Subject: Indian Point 3 Nuclear Power Plant
Docket No. 50-286
I.E. Bulletin 79-07

NOTES OF TELEPHONE CONVERSATIONS

Summary of conversations between United Engineers & Constructors and Nuclear Regulatory Commission Personnel on the Subject of Modeling of Elbows and Associated Effects on the Results of the Analyses Performance in Response to NRC I.E. Bulletin 79-07.

FIG 2

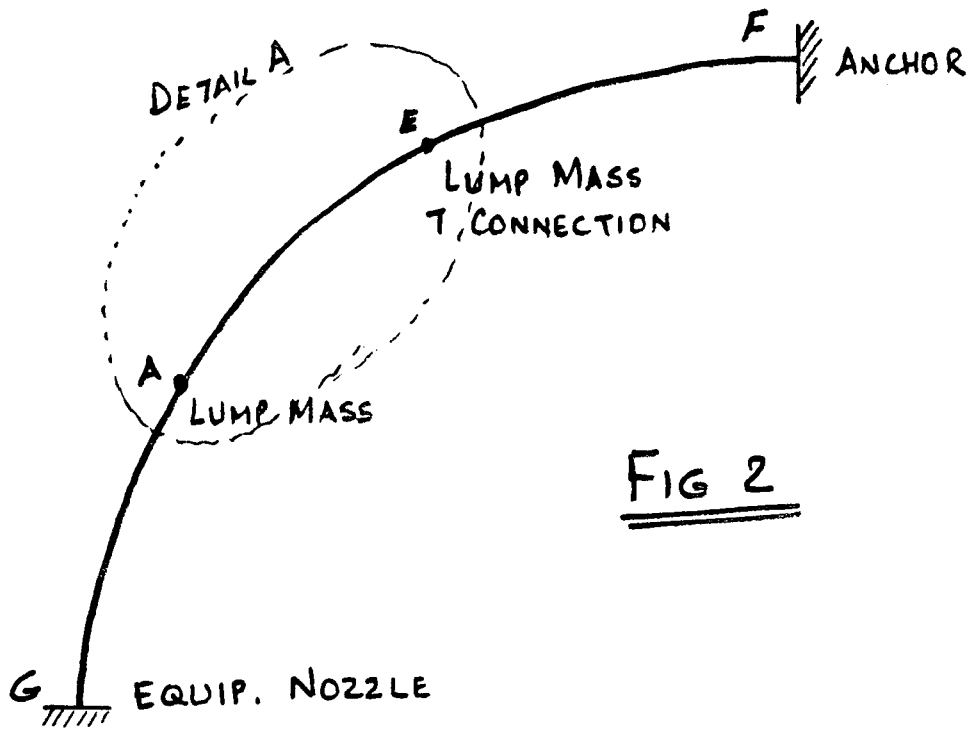
Problem No. 2 - In modeling large radius piping sections, two techniques are used:
(Refer to Fig. 2)

- a. The section is divided into a number of subsections each modeled with elbow elements. Due to an application limitation in the UE&C ADL-2 Program, which does not accept elbow-to-elbow modeling, short straight sections of pipe are introduced between each curved section (i.e., GA, AB, DE, EF in Fig. 2). Elbows between these sections are included as in the standard elbow cases. This condition is therefore analogous to the one explained in the Problem No. 1 cases. Here, however, additional calculations are required to identify the coordinates of the short straight section point C and the chances for errors are increased.

- b. The section is divided in a series of straight subsections. This technique requires only that the coordinates of both ends of each section be calculated. The algorithm used internally by the computer to fit an elbow of a given radius R is not used here and consequently the problems of the types discussed under (a) above do not exist.

Problem No. 2 - The elbow-to-elbow modeling technique for long radius sections was not used for IP-3 (See Table 1).
